From: [Gwen Long](#)
To: Joobrien@cityofmadison.com; [Fries, Gregory](#); [Board of Public Works](#)
Cc: [Conklin, Nikki](#); [Crawley, Katie](#)
Subject: Pheasant Branch Watershed Study survey
Date: Monday, August 22, 2022 5:41:01 PM

Thank you for your hard work on the Watershed projects. This is a very complex issue. The Pheasant Branch Watershed survey did not have much room for public comments so I am sending you my questions/comments regarding the project in this email.

How can we provide meaningful public comments when there is no Project Plan for the Sauk Creek Greenway Restoration in the August 1, 2022, 393 page, Pheasant Branch Watershed Study?

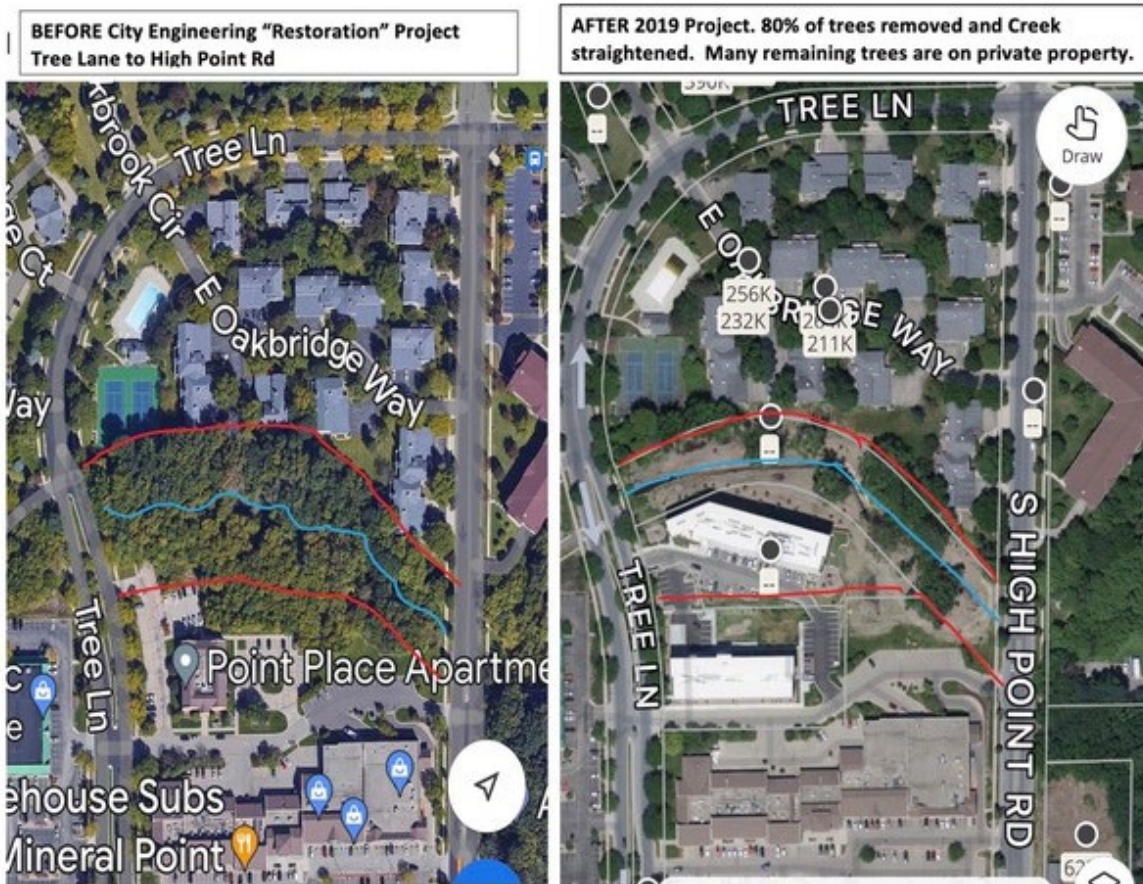
2. It appears Greenbriar Apartments owns the section of land between the already completed SC Greenway segment and the 1 mile proposed project (see attached picture below, Red roofed apartments bottom right).
What is the cost to taxpayers and plan for that section of the creek which appears to be on private property?

6. What exactly are the plans for reconstructing/dredging the "broken" retention pond in Sauk Creek Greenway, by Sauk Creek Dr and St. Lawrence? It is shown as outside the Greenway Project Area on the Project Maps. Although it has been "broken" for over 15 years, it is on all of the watershed maps as a retention pond. It does not collect any street water. We don't hear anything about the plans for this valuable non-functioning retention pond. It could be incorporated into a Regenerative Stormwater Conveyance system.

2. Greenbriar Apartments have a section of creek running through their private property. What is the cost to taxpayers to acquire that land?

6. What are the plans for the retention pond in the middle of the project that has been “broken” and not maintained for over 15 years? It has not been maintained or acted as a retention pond in the 15 years that we have lived here. The City engineers are aware of this pond but I see it outside the red Greenway Project Area.
